SERVICE INSTRUCTION

Introduction of new floats (pair) for ROTAX® Engine Type 912 and 914 (Series)

ATA System: 73-00-00 Fuel system

Fig. 1
Comparison of floats

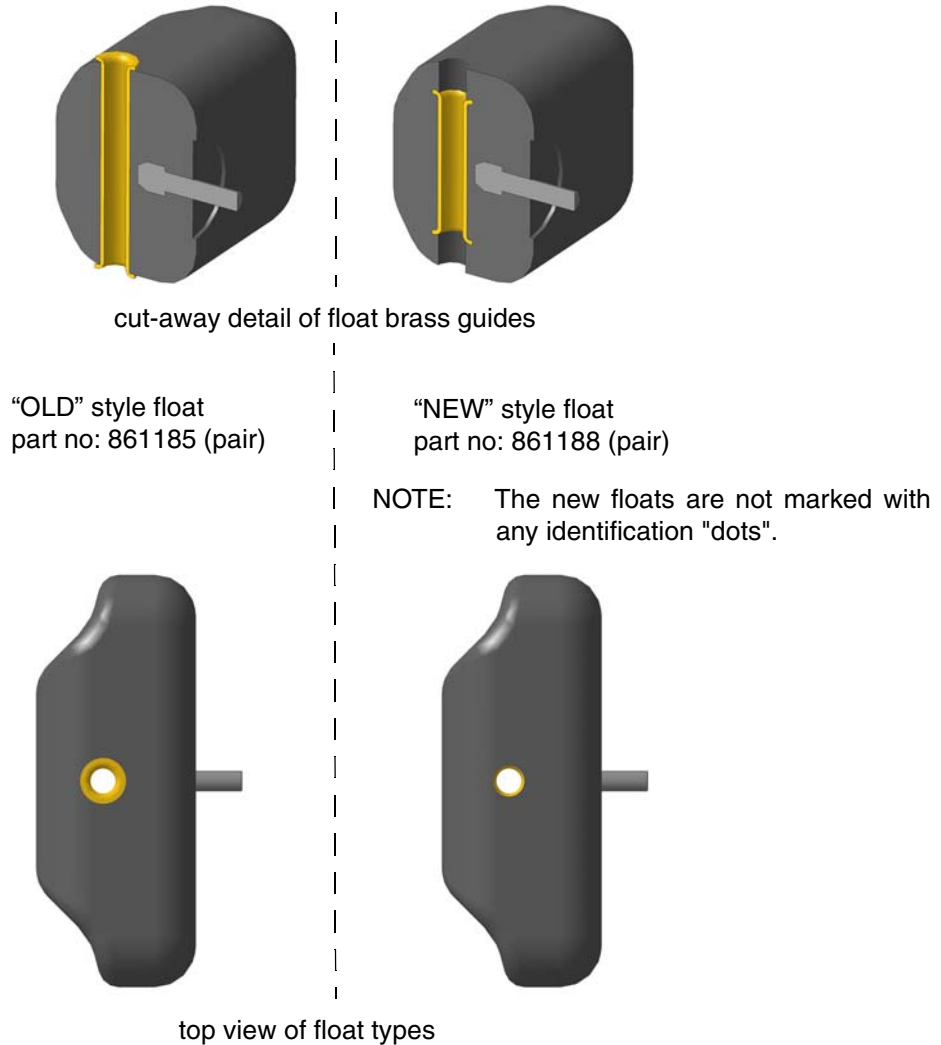
In the course of continuous development and standardization, new floats (pair) ROTAX® part number 861188 have been introduced. These new floats (pair) are manufactured with a higher compaction rate and contain a recessed brass guide. See Fig. 1.

As per Maintenance Manual Line (MML) let the floats dry for 1-2 minutes. Only weigh dry floats. Due to their higher compaction rate, the dry weight of the new floats (pair) part no. 861188 may be higher than the previous floats. But in no case the max. weight (of both floats together) is allowed to exceed 7 grams and so still applies. See relevant Maintenance Manual Line Chapter 12-20-00.
